Commonwealth Edison Company
LaSalle Generating Station
2601 North 21st Road
Marseilles, IL 61341-9757
Tel 815-357-6761

Subject: LaSalle County Nuclear Power Station Units 1 and 2
Application for Amendment of Facility Operating
Licenses NPF-11 and NPF-18, Appendix A, Technical
Specifications, changing the definition of Channel
Calibration and correcting miscellaneous errors in the
Technical Specifications and Bases.
NRC Docket Nos. 50-373 and 50-374

ATTACHMENT A
DESCRIPTION OF SAFETY ANALYSIS OF THE PROPOSED CHANGES

FIGURE 1
 TRAVERSING IN-CORE PROBE SIMPLIFIED DIAGRAM

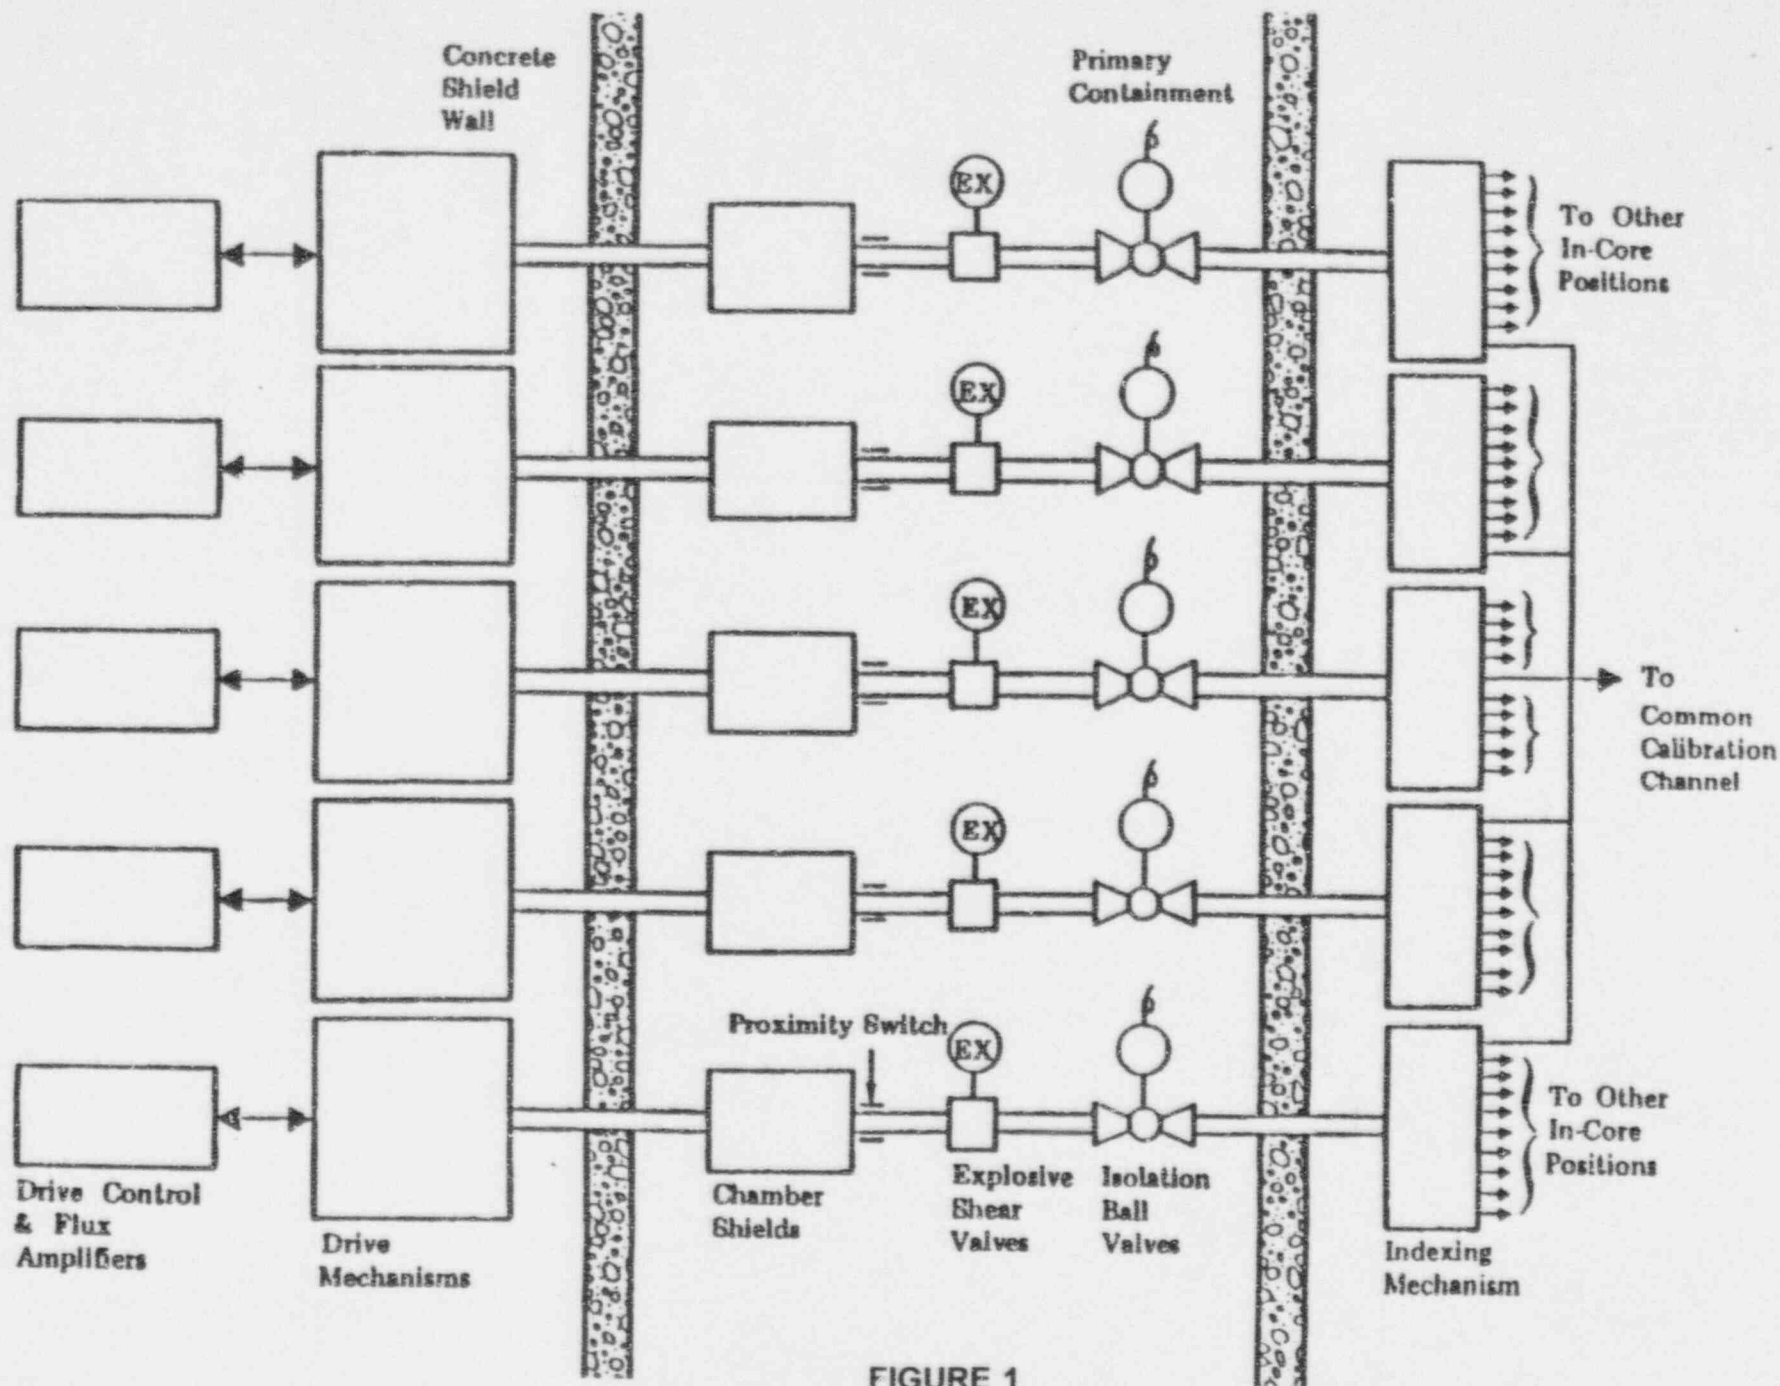
- b. Primary containment isolation valve group 7, TIP system isolation has two valves outside of the primary containment for each of five penetrations. The inboard isolation is an automatic isolation valve that automatically closes on an inboard isolation of the primary containment due to trip functions A.1.a.(1), reactor vessel water level low, level 3; A.1.b, drywell pressure - high. In addition, Group 7 valves close on a manual initiation of the inboard valves, as required by B.1.

The outboard isolation valves for the TIP system penetrations are explosive squib valves. If a TIP system probe(s) is inserted past the inboard isolation valve(s) and will not withdraw to allow closure of the associated ball valve(s) when a valid isolation actuation signal is received, procedures require manually actuating the associated TIP system explosive squib valve(s) to shear the respective TIP cable and isolate the line. The explosive squib valves are controlled using a keylock switch in the main control room and are required to be operable by TS 3.6.3 and verified operable per TS SR 4.6.3.5 on a periodic basis. These valves are not actuated from the primary containment manual isolation logic due to the nature of the TIP system. Therefore, group 7, TIP system outboard valves, is proposed to be deleted from TS Table 3.3.2-1, Functional Unit B.2. For information, a simplified diagram of the TIP system component arrangement is included as Figure 1 at the end of this attachment.

- b. TS Table 3.3.2-1, Trip Function B.2, valve groups operated by the manual isolation signal is proposed to be changed to delete TIP isolation valves group 7 from the list.
- c. Note (e) is proposed to be deleted from Trip Function 4.a in TS Table 3.3.6-1.
- d. Note # is proposed to be corrected to be Note ## in the last paragraph on Bases page B 3/4 3-1.
